RE: DRAINAGE PLAN SUBMITTED FOR WARD RESIDENCE, LOT 17, BLOCK 10,
TRACT 2, UNIT 1, NORTH ALBUQUERQUE ACRES (C22/D41) (PWD-94-231),
ENGINEER'S STAMP DATED 1/13/95.

DRAINAGE PLAN

LOT 17, BLOCK 10, TRACT 2, UNIT 1

RE: DRAINAGE PLAN SUBMITTED FOR WARD RESIDENCE, LOT 17, BLOCK 10, TRACT
2, UNIT 1, NORTH ALBUQUERQUE ACRES (C22/D41), (PWD-94-231),
ENGINEER'S STAMP DATED 9/22/94.

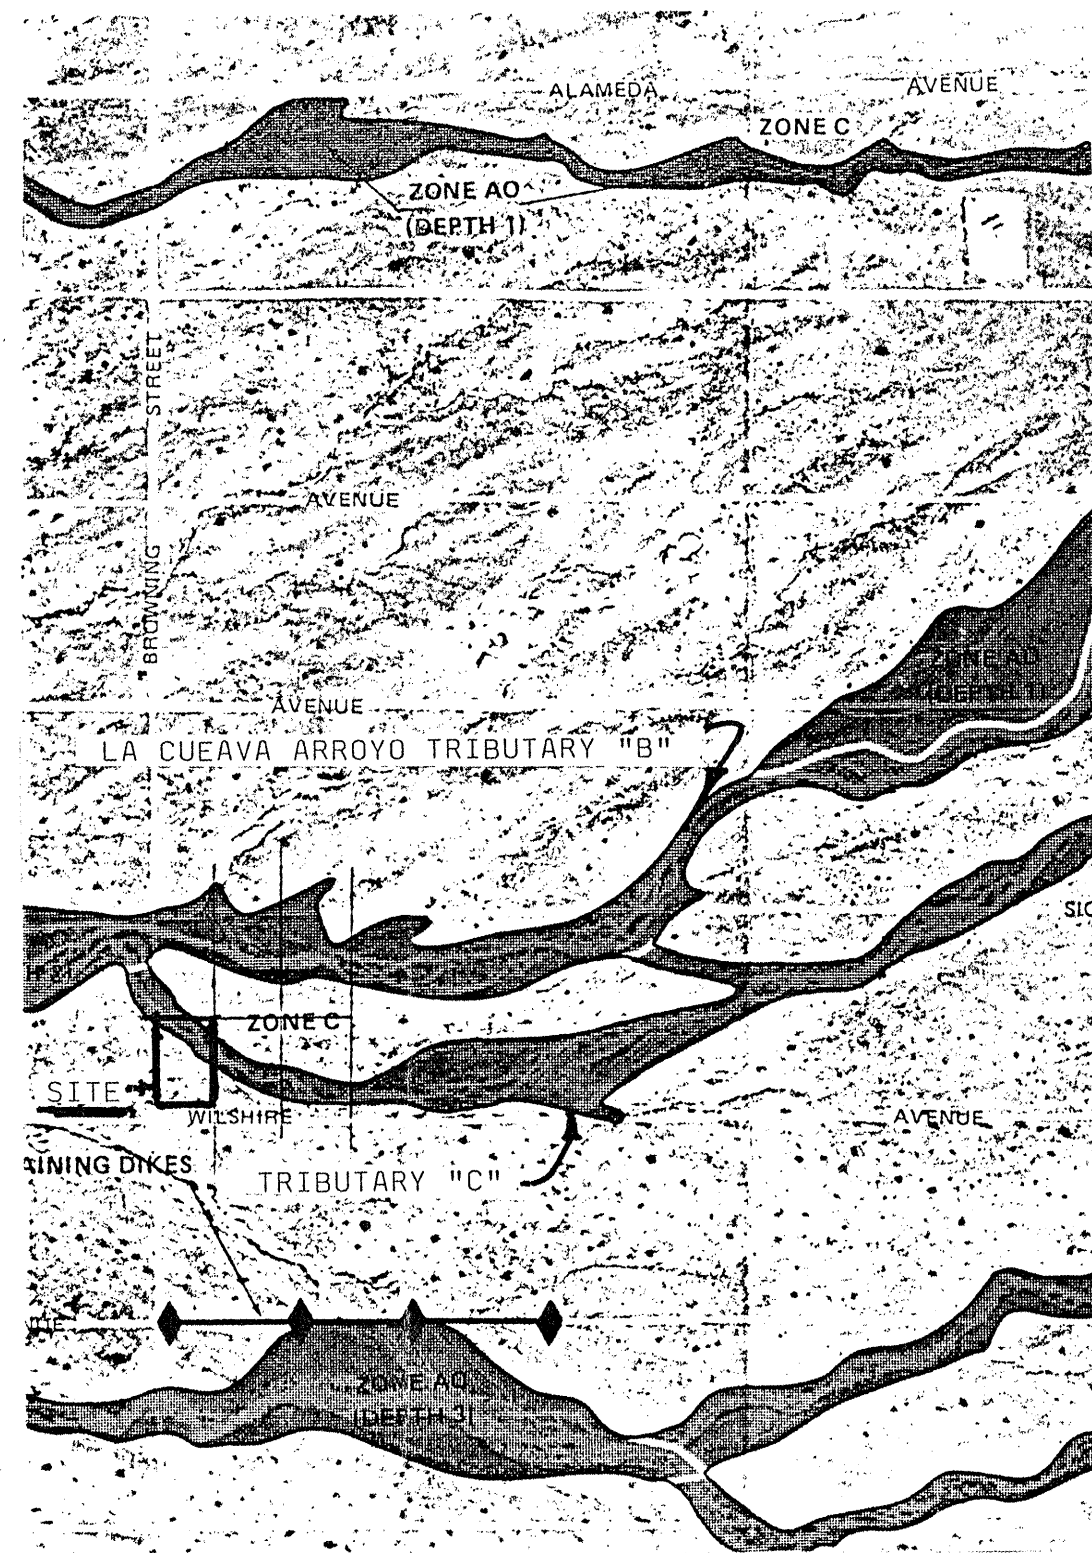
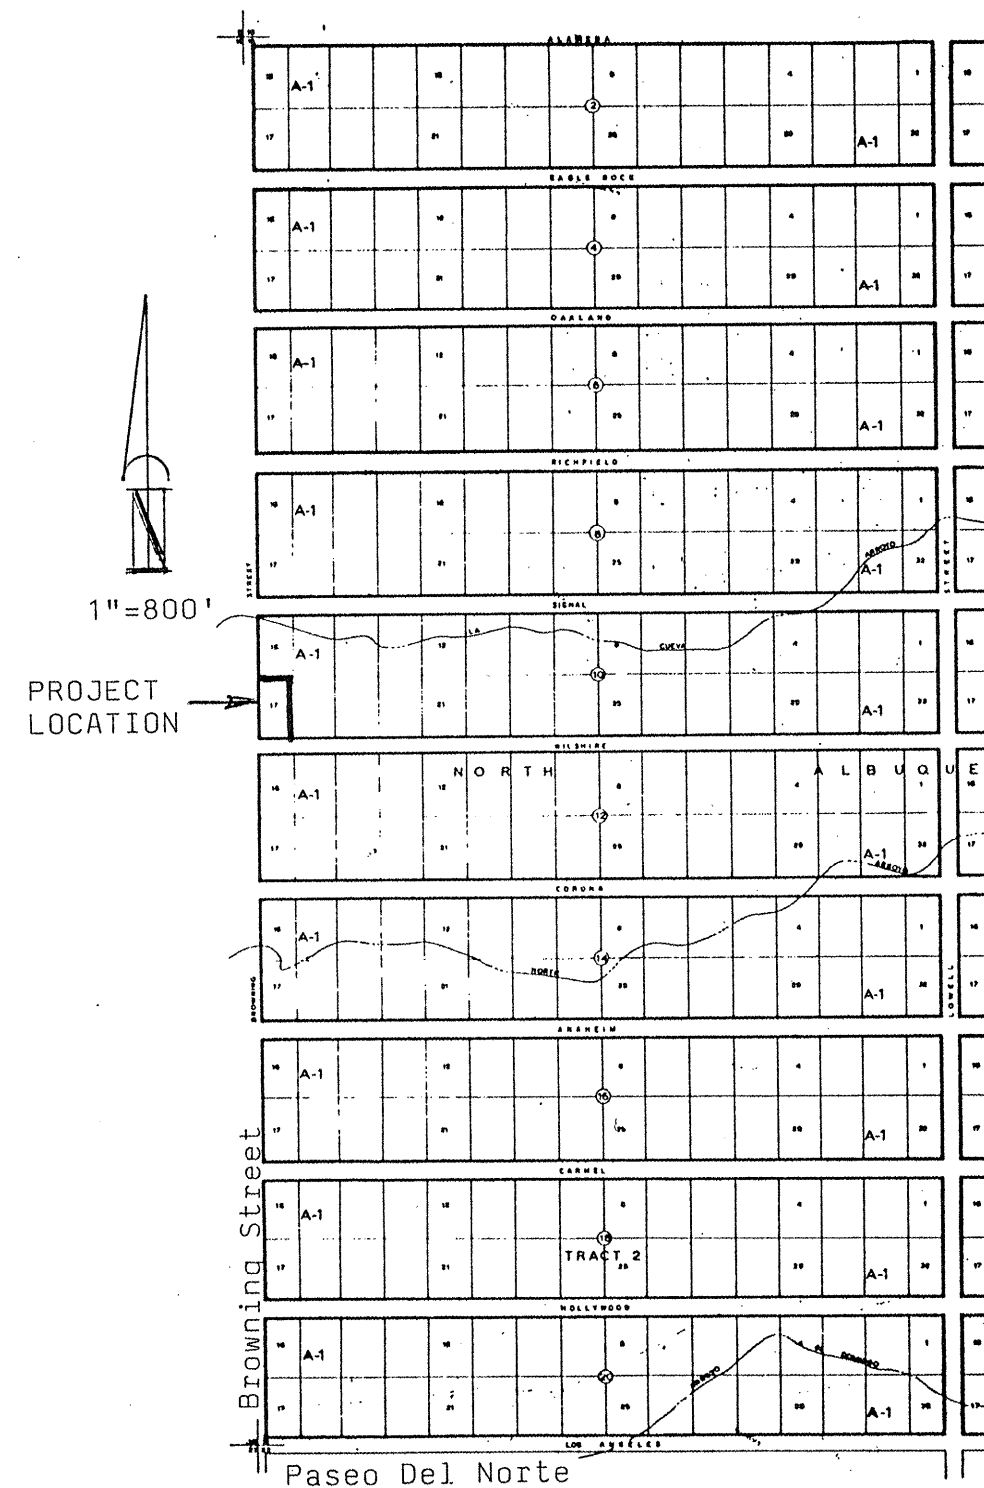
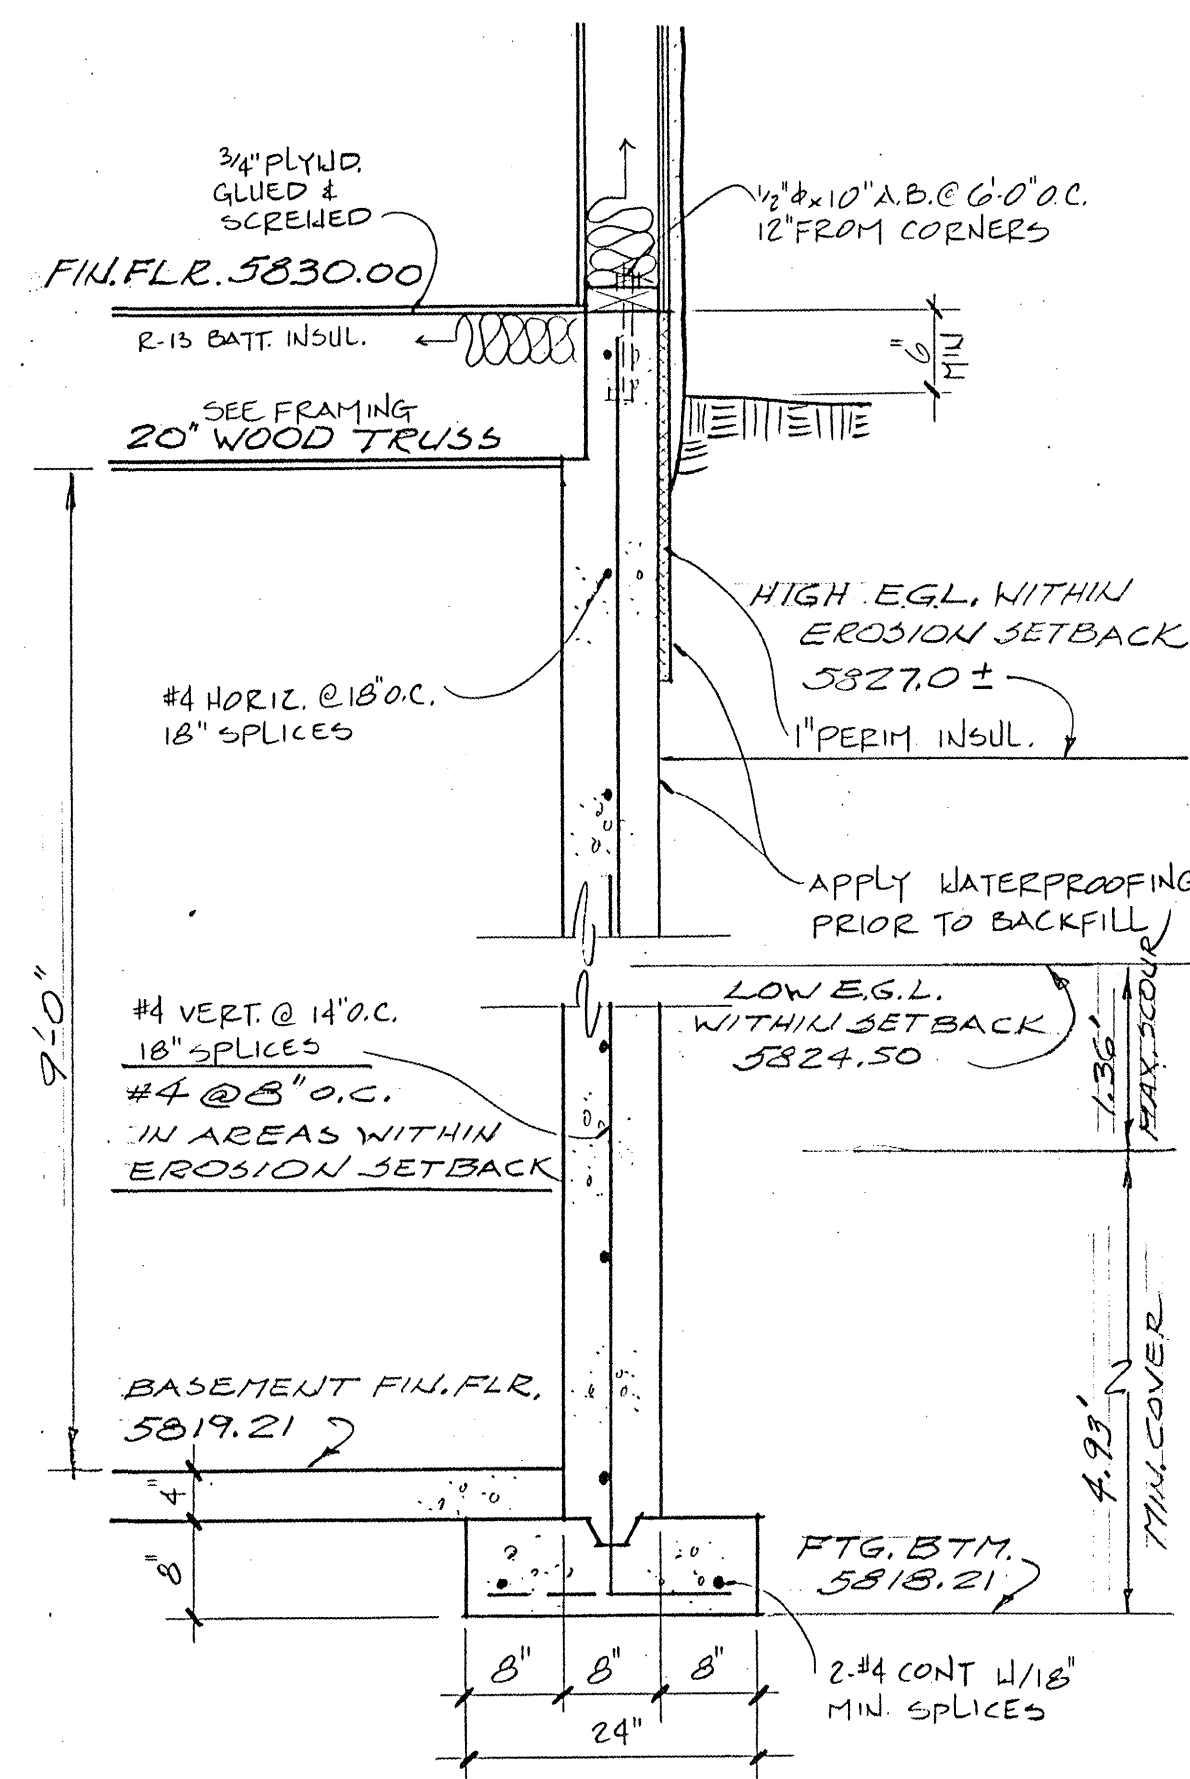
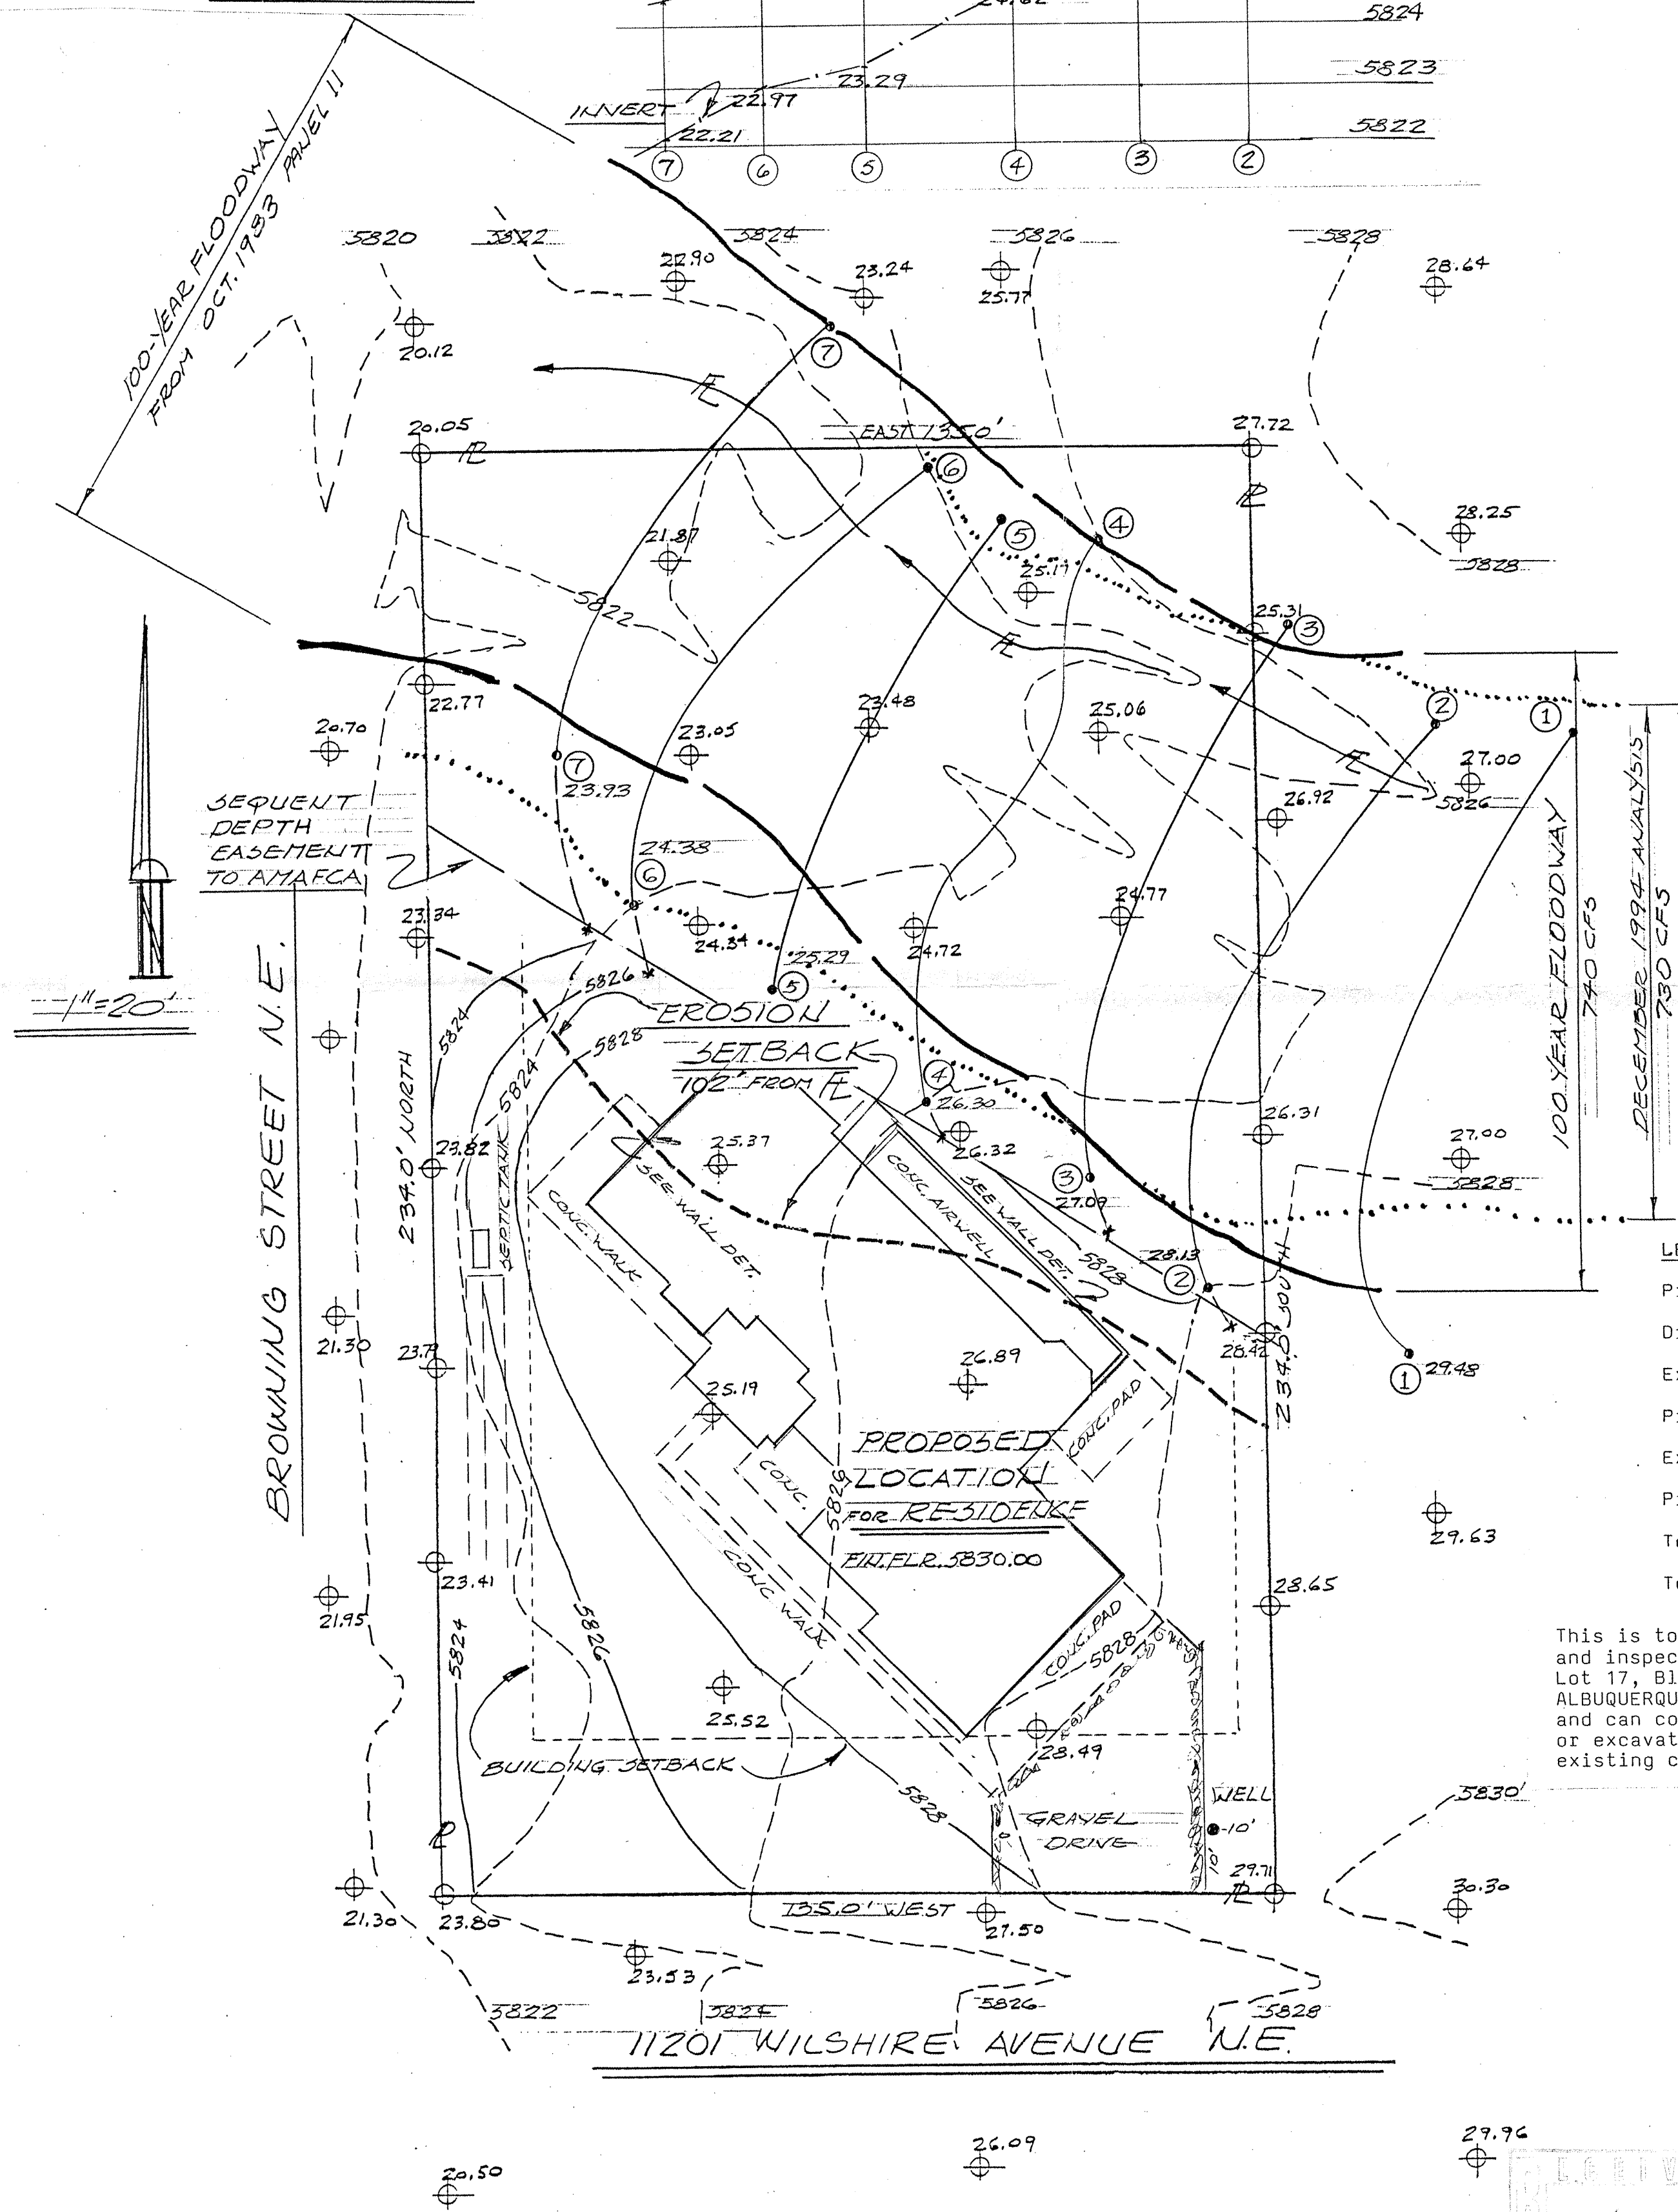
1. Please provide the existing and proposed hydrology for the site per Section 22.2 of the DPM.
2. Please verify the flow calculated for the La Cueva Arroyo. The plan must include the delineation of the off-site drainage basin. Typical land treatment percentages used to determine off-site flows for North Albuquerque Acres are: A=43%, B=20%, C=20%, and D=17%. We understand that this arroyo has been studied under an existing contract with FEMA, so you may wish to compare your calculated flow with the flow determined by the study.

3. A drainage easement for the flood plain must be approved by and dedicated to AMAFCA prior to approval of the drainage plan. The limit of this easement is typically the energy grade line (EGL), or the sequent depth. Please plot the EGL and the proposed easement on the plan.

4. Please include the standard Engineer's statement regarding inspection of the site as outlined in the County ordinance. This statement must be signed and dated.

5. This plan does not adequately address perimeter fencing. The plan should state that perimeter fencing is or is not proposed for the site. Any perimeter fencing proposed must address how off-site flows are to be conveyed through the property.
6. Please show the proposed driveway location. Will a culvert be required? If so, provide a culvert/weir analysis for both normal and plugged conditions.
7. Please show the proposed water well location on the plan.
8. The intent of this plan is unclear. Typically, drainage plans are approved for building permit when all elements, including the erosion setback requirements, have been met.

Reference: Section 22.2 of the Development Process Manual, City of Albuquerque, New Mexico, January 1993.

Off-Site Area: La Cueva Arroyo Tributary "C" traverses the rear third of the subject property. Area = 300 acres and flow for the 100 year, 6 hour storm is predicted to be 730 cfs through the lot. See attached Exhibit "A".

E.G.L. PLOT
1"=20' HORIZ & 1"=2' VERTICAL

This is to certify that I have visited and inspected the site at 11201 Wilshire NE, Lot 17, Block 10, Tract 2, Unit 1, NORTH ALBUQUERQUE ACRES, Bernalillo County, N.M. and can confirm that no grading, filling, or excavation has occurred since this existing contour map was prepared.

The pad is also outside of the EGL and the erosion setback, although these determinations are more subjective for two reasons. (1) The channel cross-section overbank slope is very mild, making lateral spread highly sensitive to slight differences in topography. (2) The thalweg of the existing channel is ill-defined. I'm deferring to your FL placement.

I note that the FF is at 5830, roughly 5 feet higher than the existing grade on the west end. I highly endorse this degree of conservative design, given the possibilities discussed above.

While the pad is not in the designated scour zone, some stray water could brush along its north face. I would encourage ample stemwall depth for this reason, even if the sediment design guide doesn't require it.
